SOLO EVENTS BOARD

SOLO EVENTS BOARD | November 24, 2014

Figure 1 – Location of the Controlled Area

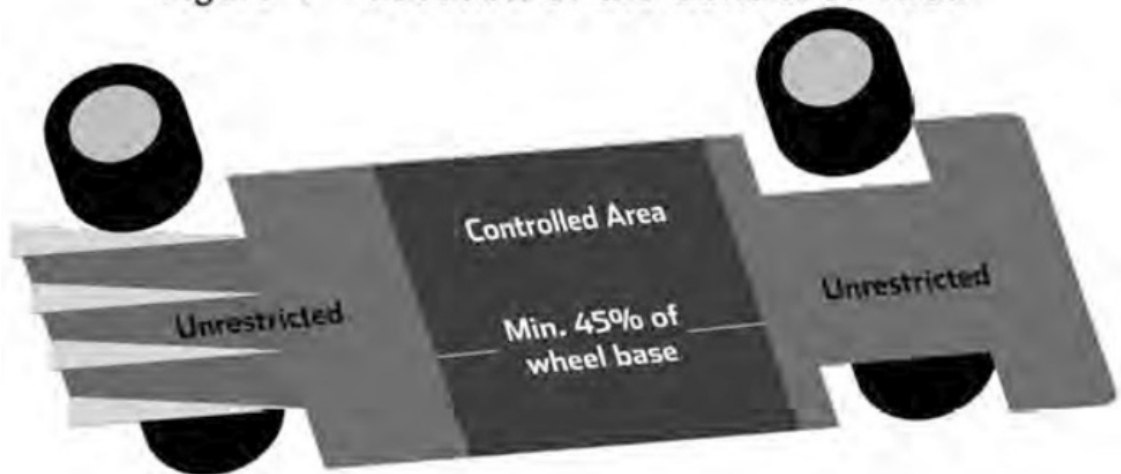
1. The total area when viewed from the top of **front and rear** wings shall not exceed 8 square feet. **Area calculation is of the airfoil element plan view and does not include side plates. Side plate area and element profile are unrestricted.**

2. **Cars with underbody features built in excess of P2 aerodynamic allowances (2015 GCR Section 9.1.8.C.1.E) must meet a weight penalty of 100 lbs. and must be constructed within the following limitations:**

a. **For the full width of the body the floor pan will be a minimum of 45% of the wheelbase; the lower surface (surface licked by the air stream) shall not exceed +/-2.54 cm (1 inch) deviation in any longitudinal section through the plane forming the bottom of the tub or chassis floor. The 45% minimum (of the wheelbase) dimension is measured from the point that the surface meets the full width of the body (behind the front wheel or in front of the rear wheel). (This is not to be interpreted as requiring a floor pan beneath the motor, transaxle, transmission, or final drive housing.) See Figure 1.**

b. **No aerodynamic devices (e.g. "skirts," body sides, etc.) may extend more than 1cm (0.394 inches) below this lower surface anywhere on the car to the rear of the front axle. Seat bucket or other protrusions shall not circumvent this rule.**

Figure 1 – Location of the Controlled Area

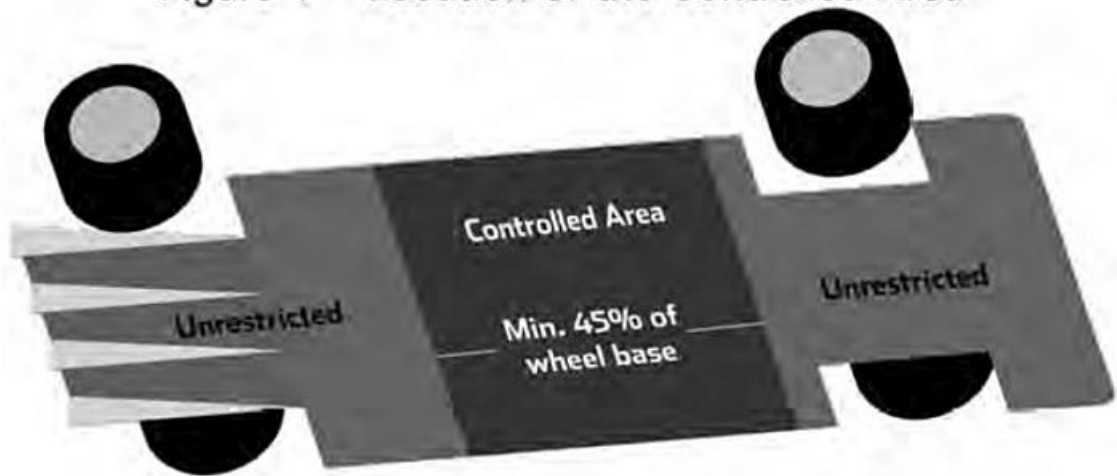
1. The total area when viewed from the top of *front and rear* wings shall not exceed 8 square feet. *Area calculation is of the airfoil element plan view and does not include side plates. Side plate area and element profile are unrestricted.*

2. *Cars with underbody features built in excess of P2 aerodynamic allowances (2015 GCR Section 9.1.8.C.1.E) must meet a weight penalty of 50 lbs. and must be constructed within the following limitations:*

a. For the full width of the body the floor pan will be a minimum of 45% of the wheelbase; the lower surface (surface licked by the air stream) shall not exceed +/-2.54 cm (1 inch) deviation in any longitudinal section through the plane forming the bottom of the tub or chassis floor. The 45% minimum (of the wheelbase) dimension is measured from the point that the surface meets the full width of the body (behind the front wheel or in front of the rear wheel). (This is not to be interpreted as requiring a floor pan beneath the motor, transaxle, transmission, or final drive housing.) See Figure 1.

b. No aerodynamic devices (e.g. "skirts," body sides, etc.) may extend more than 1cm (0.394 inches) below this lower surface anywhere on the car to the rear of the front axle. Seat bucket or other protrusions shall not circumvent this rule.
